#### Sea Turtle Conservation; Shrimp and Summer Flounder Trawling Requirements

**ACTION:** Final rule.

**SUMMARY:** This rule revises the turtle excluder device (TED) requirements to allow the use of new materials and to modify existing approved TED designs. Specifically, this rule allows using flat bar, rectangular pipe, and oval pipe as construction material in currently-approved TED grids; using a brace bar on hard TEDs; increasing the maximum mesh size on escape flaps from 1<sup>5</sup>/<sub>8</sub> to 2 inches (4.1 to 5.1 cm); including the Boone Big Boy TED for use in the shrimp fisheries; using three large TED and Boone Wedge Cut escape openings; and using the Chauvin shrimp deflector to improve shrimp retention. This rule also adds a TED for use in the summer flounder fishery. Additionally, the rule corrects the TED regulations to rectify an oversight regarding the maximum size chain that can be used on the Parker TED escape opening flap.

FIGURE 11 TO PART 223 -- MODIFIED FLOUNDER TED

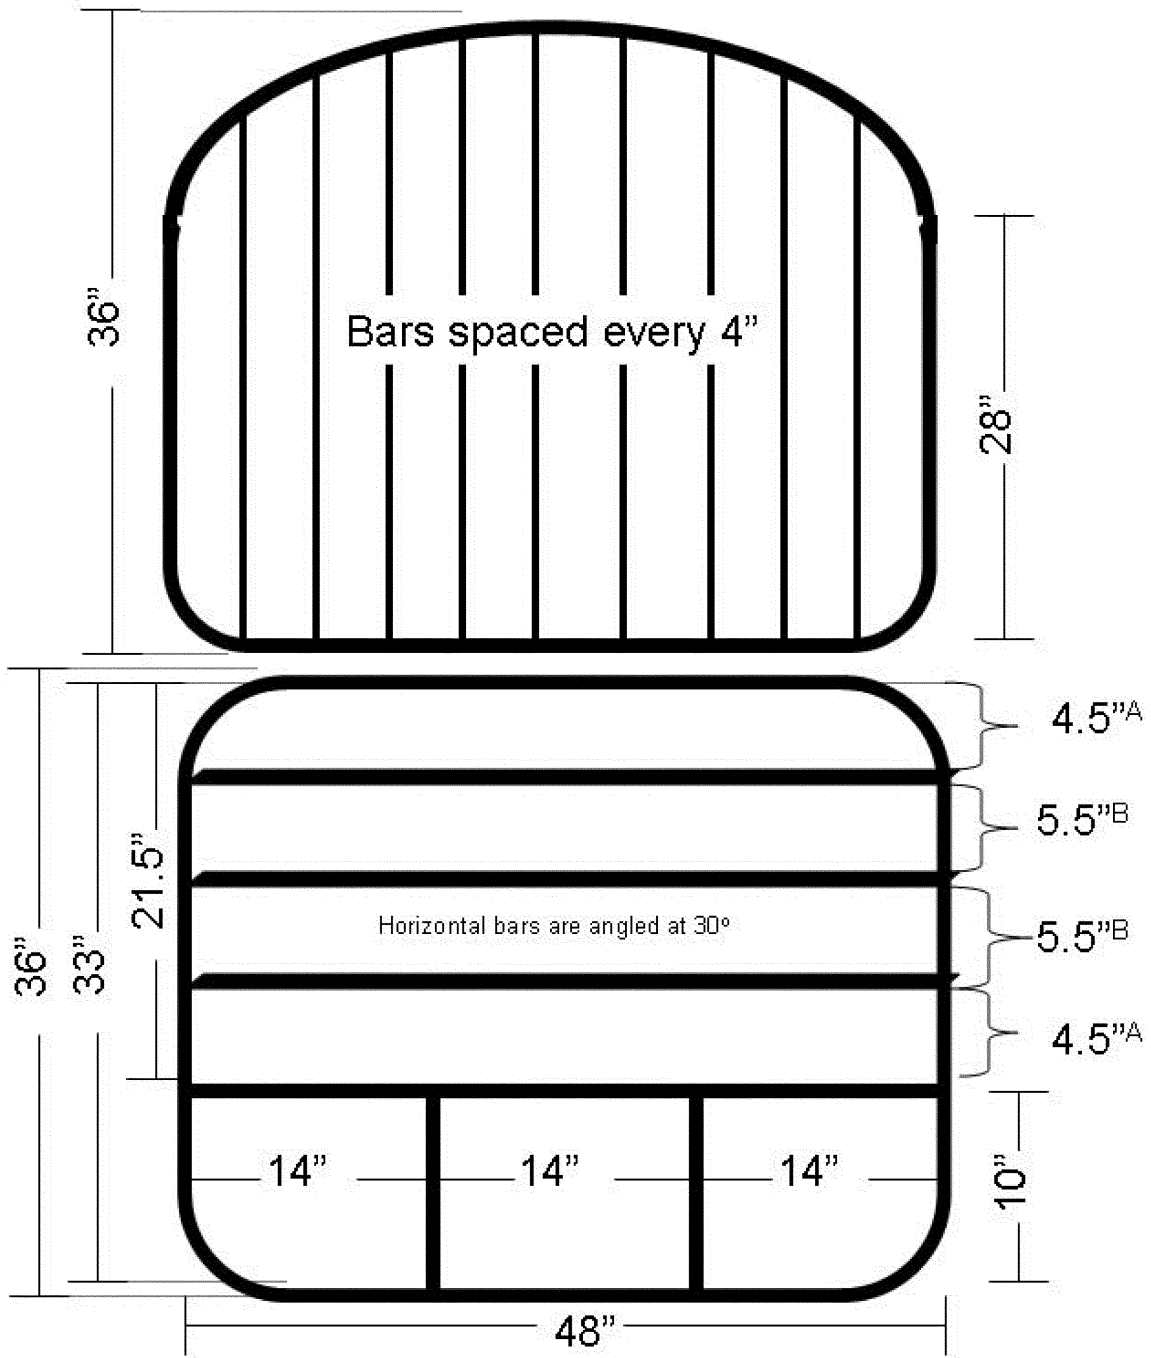
(4) Modified flounder TED. (Figure 11 to this part). The modified flounder TED is approved for use only in the Atlantic summer flounder bottom trawl fishery. The modified flounder TED is not an approved TED for use by shrimp trawlers. The modified flounder TED incorporates two separate grid frames that are attached together. The frames of the grids must be constructed of at least 1 1/4 inch (3.2 cm) outside diameter aluminum or steel pipe with a wall thickness of at least 1/8 inch (0.32 cm). Each of the two grids of the modified flounder TED must have outside dimensions of at least 36 inches (91.4 cm) in height and at least 48 inches (121.9 cm) in width. The upper grid is equipped with vertical deflector bars, which must be constructed of aluminum or steel flat bar with a minimum depth of 1 1/4 inches (3.2 cm) and a minimum thickness of 3/8 inch (0.95 cm). Vertical deflector bars must be connected to the top and bottom of the upper grid. The space between the deflector bars of the upper grid must not exceed 4 inches (10.2 cm). The lower grid is fabricated with both horizontal and vertical deflector bars, creating four narrow horizontal openings at the top, and three large rectangular openings along the bottom of the grid. The lower grid must have at least three horizontal deflector bars, constructed of aluminum or steel flat bar with a minimum depth of 1 1/2 inches (3.8 cm) and a minimum thickness of 3/8 inch (0.95 cm), which are connected to each side of the grid and angled at 30° from the horizontal plane. Below this, a fourth horizontal deflector bar must be constructed of aluminum or steel pipe with a wall thickness of at least 1/8 inch (0.32 cm) and with a 1 1/4 inch (3.2 cm) outside diameter. These horizontal deflector bars must yield maximum spacings of 4 1/2 inches (11.4 cm), 5 1/2 inches (14.0 cm), 5 1/2 inches (14.0 cm), and 4 1/2 inches (11.4 cm), as constructed from

top to bottom and measured between the leading edges of adjacent deflector bars. There must be a maximum 10-inch (25.4 cm) space between the bottom-most horizontal deflector pipe bar and the grid frame bottom. Two additional vertical pipe sections running from the bottom of the grid frame to the bottom-most horizontal deflector pipe bar must divide the opening at the bottom into three rectangles, each with a maximum height of 10 inches (25.4 cm) and a maximum width of 14 inches (35.6 cm). This TED must comply with paragraph (a)(2) of this section. The upper and lower grids of this TED must be laced together with heavy twine no less than 1/4 inch (0.64 cm) in diameter in order to maintain a consistent angle in both sections. There may be a gap between the two sections not to exceed 1 inch (2.54 cm). The angle of the entire TED frame must be between 30° and 45° from the normal, horizontal flow through the interior of the trawl. The entire width of the escape opening from the trawl must be centered on and immediately forward of the frame at the top of the net when the net is in its deployed position. The slope of the grids and the vertical deflector bars from forward to aft is upward. The modified flounder TED must use an escape opening consistent with paragraph (a)(7)(ii)(B), (C), (D), or (E) of this section. A webbing flap, as described in paragraphs (d)(3)(ii), (iii), or (iv) of this section, may be used with this escape opening, so long as the minimum opening size is achieved. This TED may not be configured with a bottom escape opening. Installation of an accelerator funnel is not permitted with this TED.

FIGURE 17 TO PART 223 -- BOONE WEDGE CUT ESCAPE OPENING

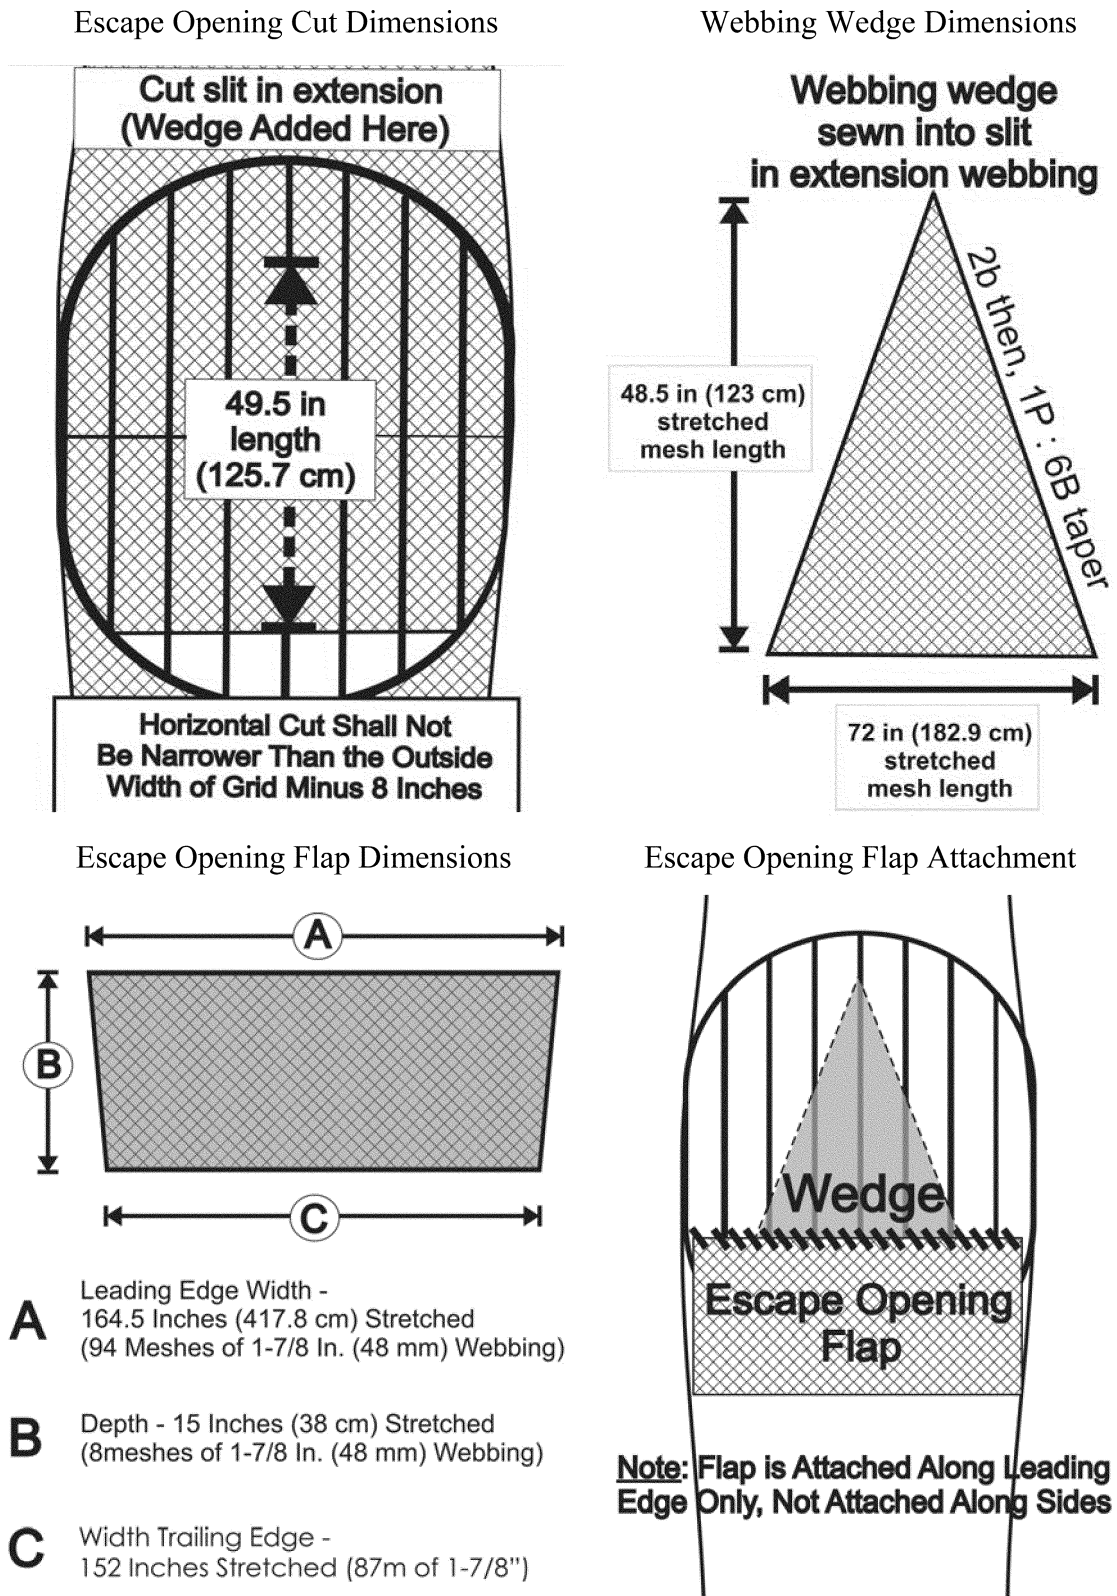
(D) Boone Wedge Cut opening. (Figure 17 to this part). The escape opening is made by making two cuts in the TED extension; one cut is fore and aft (i.e., along the length of the extension) and the other cut is horizontal to the extension. The horizontal cut is 50 meshes long and begins at a point 4 inches (10.2 cm) inward from the outside edge of the grid on one side and runs to the same point on the opposite side of the grid. The fore and aft cut begins in the middle of the horizontal cut and runs forward 49.5 inches (125.7 cm) toward the front edge of the TED extension. The added wedge of webbing is attached along its two leading edges to the edges of the fore and aft cut. The webbing wedge is made of 1 7/8 inch (4.8 cm) webbing and must have at least 41 meshes measuring at least 72 inches wide (182.9 cm) along its base (aft edge). The height of the wedge must measure at least 48.5 inches (123 cm). The top of the wedge is two bars across the leading edge then cut with a 1 point then 6 bar taper. A webbing flap, as described in paragraph (d)(3)(iv) of this section, may be used with this escape opening, so long as the minimum opening size is achieved.

(iv) *Boone Wedge Cut opening flap.* (Figure 17 to this part). This escape opening flap is attached to the trailing

edge of the horizontal cut and the wedge. The flap is made from a piece of 1 7/8 inch (4.8 cm) webbing that is trapezoid in shape. The leading edge must be at least 94 meshes wide, stretching to at least 164.5 inches (417.8 cm). The trailing edge is at least 87 meshes wide and at least 152 inches (386.1 cm). The two sides are at least 8 meshes long and at least 15 inches (38.1 cm). The escape opening flap is attached only to the leading edge of the escape opening cut and is not attached along its sides.

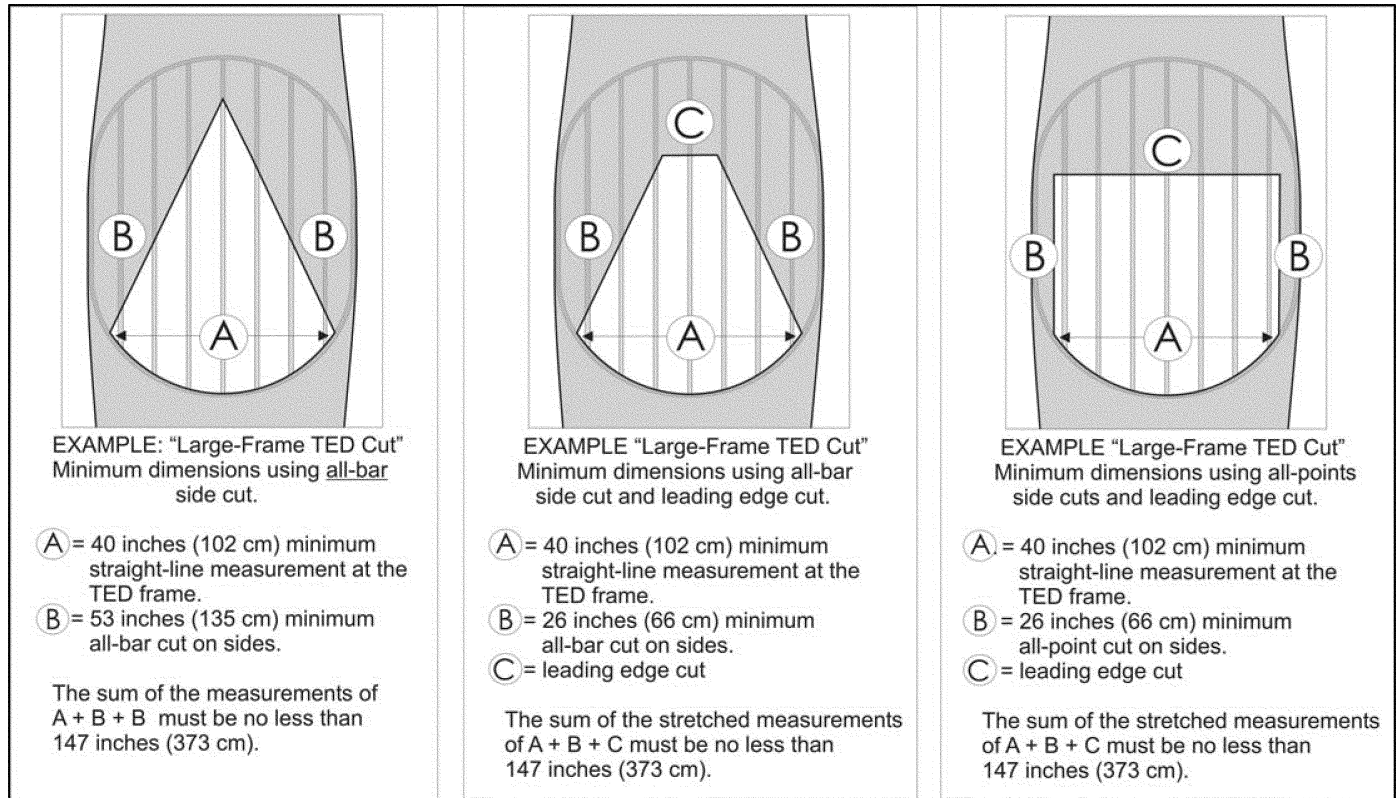
(E) Large TED openings. (Figures 18a, 18b, and 18c to this part). Large TED

escape openings may be utilized in the following configurations:

(1) A triangular cut (Figure 18a to this part), where the base of the triangle is defined by a straight-line measurement of the opening between the webbing attachment points on the TED frame that is no less than 40 inches (102 cm). The two side cuts of the triangle must be an all-bar taper from the point at which the webbing attaches to the TED frame to the apex of the triangle cut. Each side cut of the triangle must measure no less than 53 inches (135 cm). The sum of the straight-line base measurement and two side cuts must be no less than 147 inches (373 cm). The side cuts of the triangular opening may be reinforced using rib lines attached from the TED frame to the apex of the opening. A webbing flap, as described in either paragraph (d)(3)(ii) or (d)(3)(iii) of this section, may be used with this escape opening, so long as the minimum opening size is achieved.

(2) All-bar or all-points side cuts and a horizontal leading edge cut (Figures 18b and 18c to this part), where the straight-line measurement of the opening between the webbing attachment points on the TED frame may not be less than 40 inches (102 cm), and the two side cuts of the escape opening must not be less than 26 inches (66 cm) long from the points of the cut immediately forward of the TED frame. Only all-bar or all-points side cuts may be used; no combination tapers may be used when making the side cuts. The sum of the straight-line base measurement and the stretched measurements of the side cuts and leading edge cut must be no less than 147 inches (373 cm). A webbing flap, as described in either paragraph (d)(3)(ii) or (d)(3)(iii) of this section, may be used with this escape opening, so long as the minimum opening size is achieved.

FIGURES 19a AND 19b TO PART 223. CHAUVIN SHRIMP DEFLECTOR  
INSTALLATION DETAILS

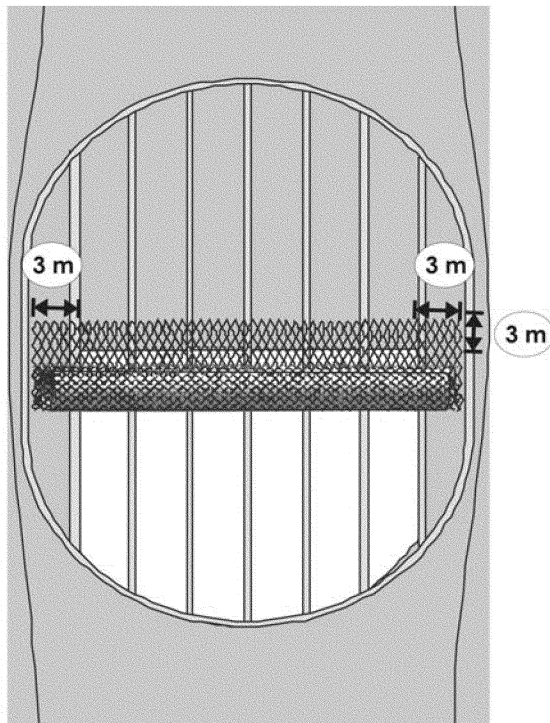
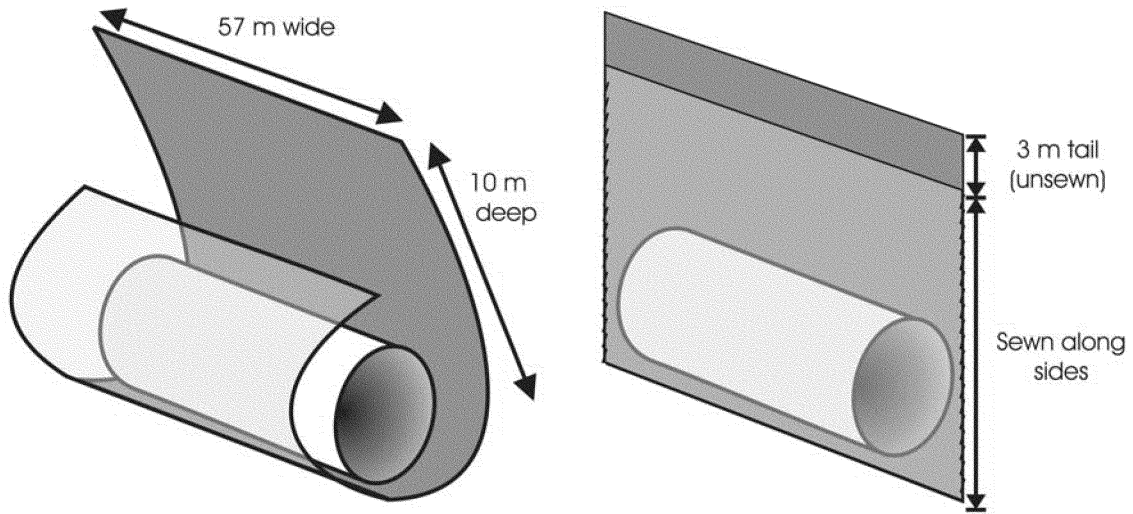
(8) *Chauvin shrimp deflector.* (Figures 19a and 19b to this part). The Chauvin shrimp deflector may be used on any approved TED design, but its installation must not reduce the minimum stretched measurements of the TED opening. The Chauvin shrimp deflector may not be installed with a bottom escape opening. The Chauvin shrimp deflector is constructed from a single piece of 3-inch (7.6-cm) inside diameter PVC pipe which measures 30 inches (76.2 cm) in length; the ends of the PVC pipe are left uncapped. A webbing or mesh bag is made and is used to encase the PVC pipe (Figure 19a to this part). The mesh bag is created using a single piece of 1 5/8 inch (4.1 cm) stretched-mesh webbing made of nylon or polyethylene with dimensions 57 meshes wide by 10 meshes deep. The leading edge of the 57-mesh piece of webbing is attached around the PVC pipe and back to the row of meshes located 7 meshes down the 10-mesh length. The ends of the webbing are sewn together on each end forming a webbing bag to assure the PVC pipe remains encased in the webbing. This leaves a 3-mesh tail hanging from the encased PVC pipe. The 3-mesh tail of the encased PVC pipe is then sewn to a single row of meshes on the inside of the trawl along the 57-mesh edge, 3 meshes ahead of the forward cut of the TED escape opening. This would allow a 3-mesh overlap to the left and right of the forward cut (Figure 19b to this part).
